**TOWN OF NEWBURGH  
PLANNING BOARD  
TECHNICAL REVIEW COMMENTS**

**PROJECT: BRACKEN 17 VENTURES, LLC**  
**PROJECT NO.: 2018-25**  
**PROJECT LOCATION: SECTION 87, BLOCK2, LOT 1.2**  
**REVIEW DATE: 27 AUGUST 2018**  
**MEETING DATE: 6 SEPTEMBER 2018**  
**PROJECT REPRESENTATIVE: VINCENT J. DOCE**

SUBDIVISION PLAN  
 LANDS OF  
**BRACKEN 17 VENTURES LLC**  
 FLEETWOOD DRIVE, TOWN OF NEWBURGH  
 ORANGE COUNTY, NEW YORK  
 DATE: AUGUST 10, 2018 SCALE: 1 IN. = 40 FT.

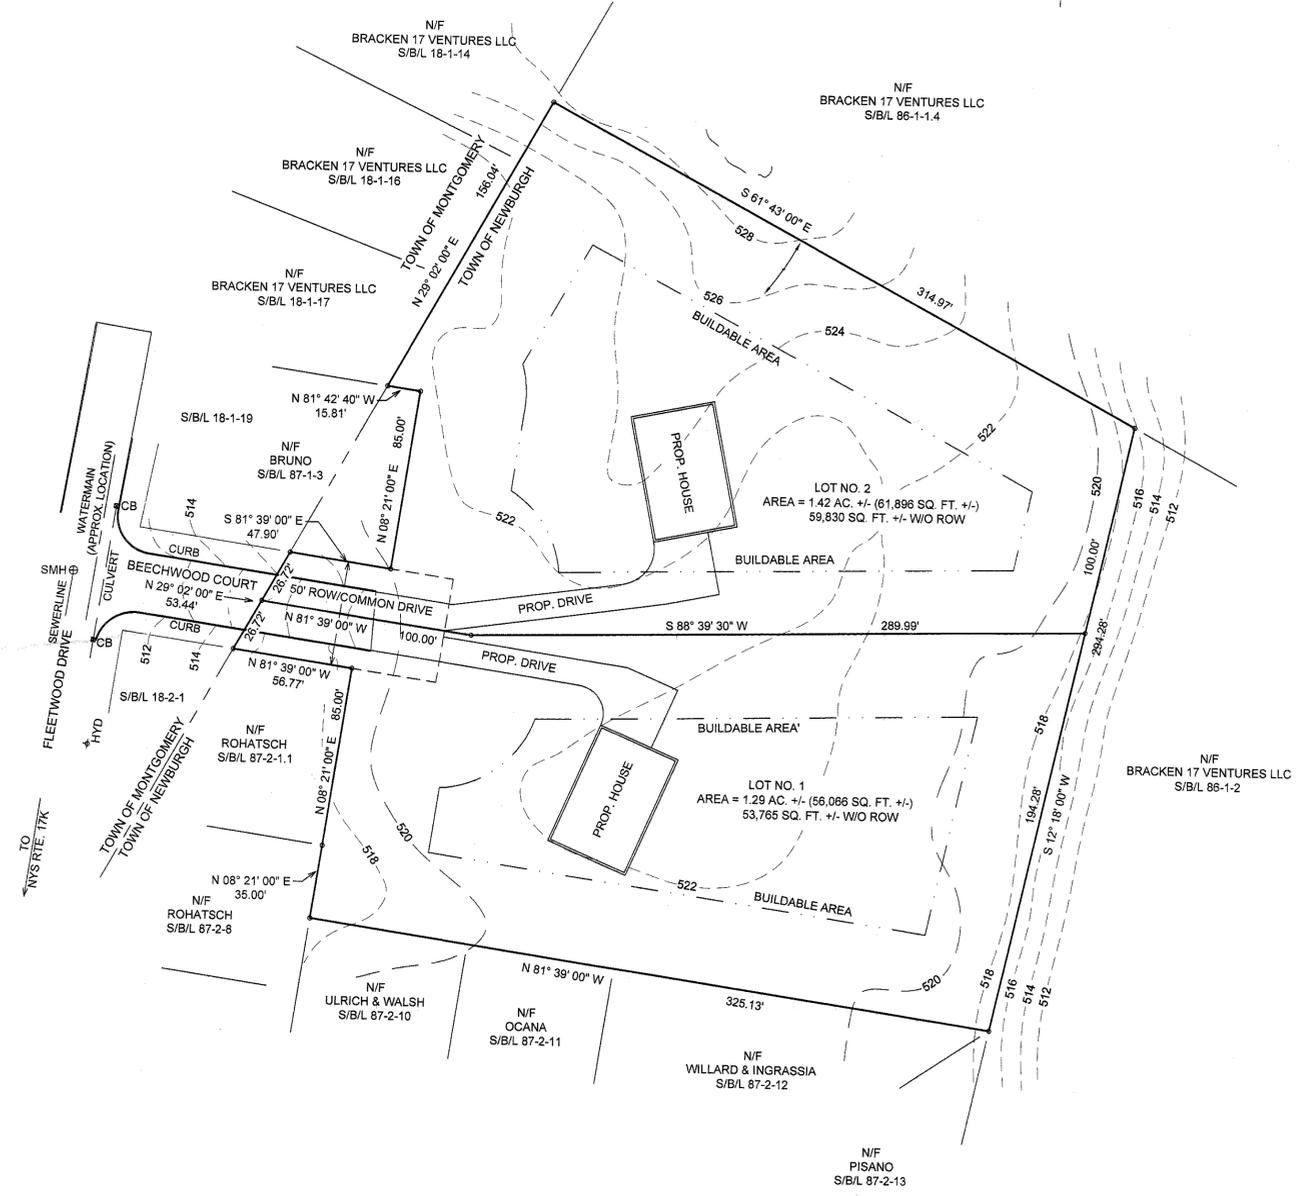
1. The status and ownership of Beechwood Court located in the Town of Montgomery should be identified on the plans.
2. County Planning referral and coordination with the Town of Montgomery is required as portions of the access road Fleetwood and Beechwood Court are located in the Town of Montgomery.

4. A scale should be added to the plan sheets.
5. Building envelope depicted on Lot #1 should be reduced showing front yard where lot meets 150 ft. lot width. Similar reduction in the rear yard on Lot #2 should be identified.

6. The house on Lot #1 is located at or near building setback lines. Notes should be added to the plans requiring field stake out by licensed surveyor and submission prior to issuance of a building permit.

7. Show improvements located on Section 87, Block 1, Lot 3 Town of Newburgh 18-1, 19 Town of Montgomery. This residence abuts what is depicted on the plans as Beechwood Court. Currently it appears that those residents utilize the dead end road as a parking area for the residential structure. Improvements including a sidewalk extend out to the curb line.

UTILITY AND GRADING PLAN  
 LANDS OF  
**BRACKEN 17 VENTURES LLC**  
 FLEETWOOD DRIVE, TOWN OF NEWBURGH  
 ORANGE COUNTY, NEW YORK  
 DATE: AUGUST 10, 2018 SCALE: 1 IN. = 40 FT.

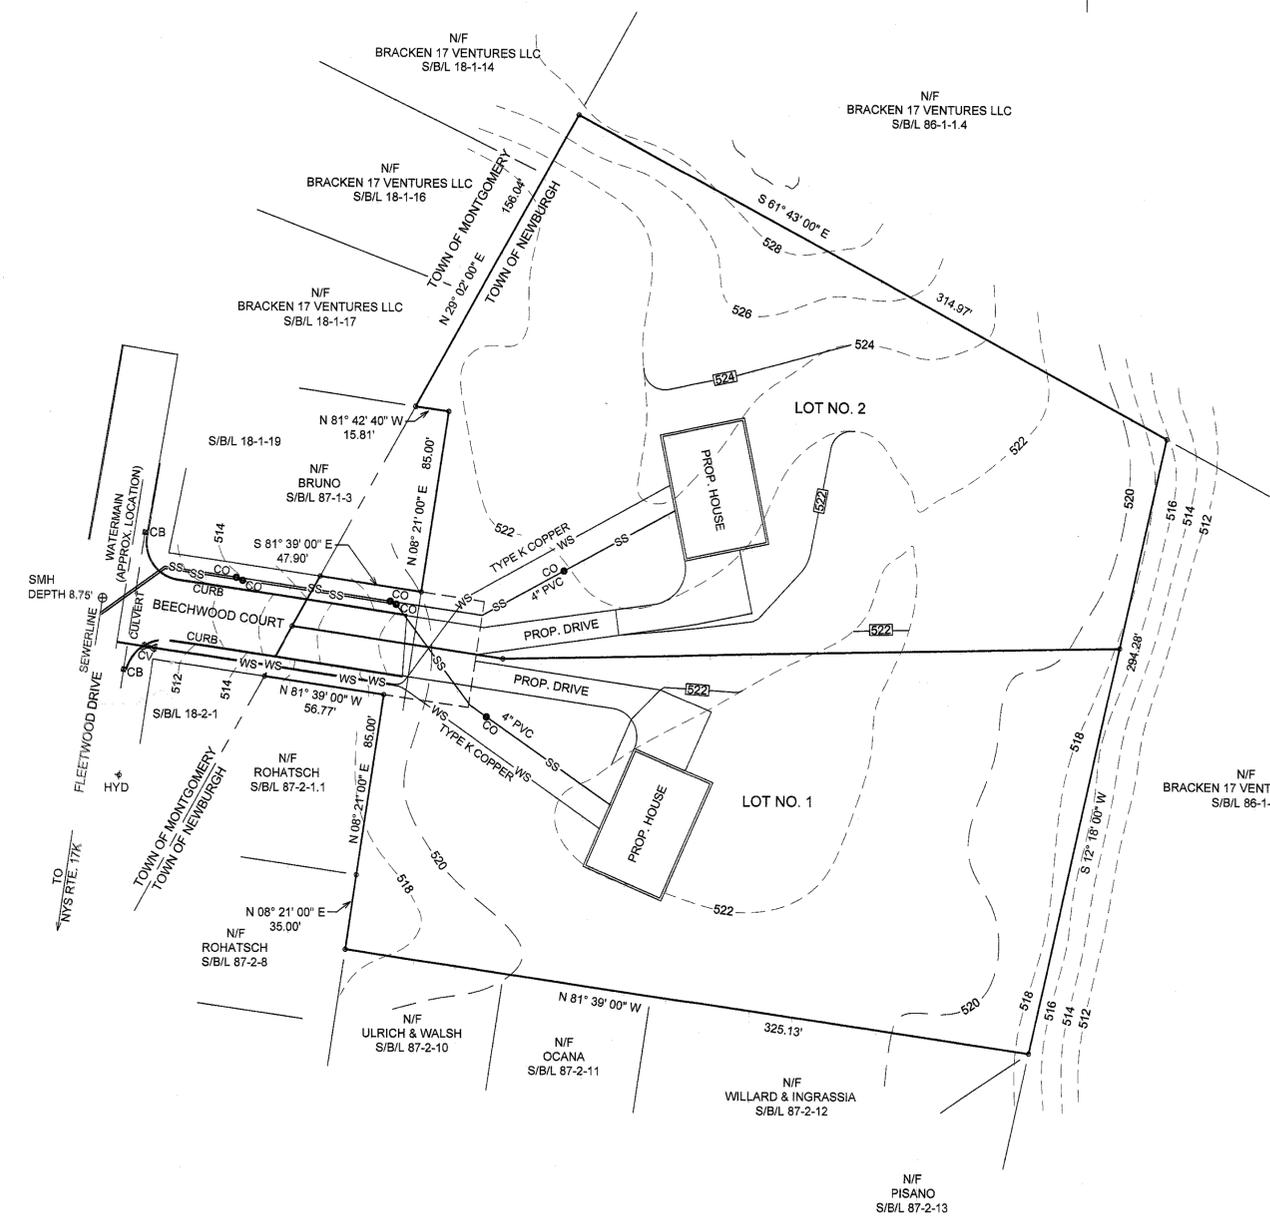
3. The proposed water and sewer lateral design makes for difficult future maintenance as separation between each may be an issue for future excavation. Confirm that separate water utilities are proposed for each structure and that appropriate easements are provided for water and sewer utilities crossing the proposed lots.
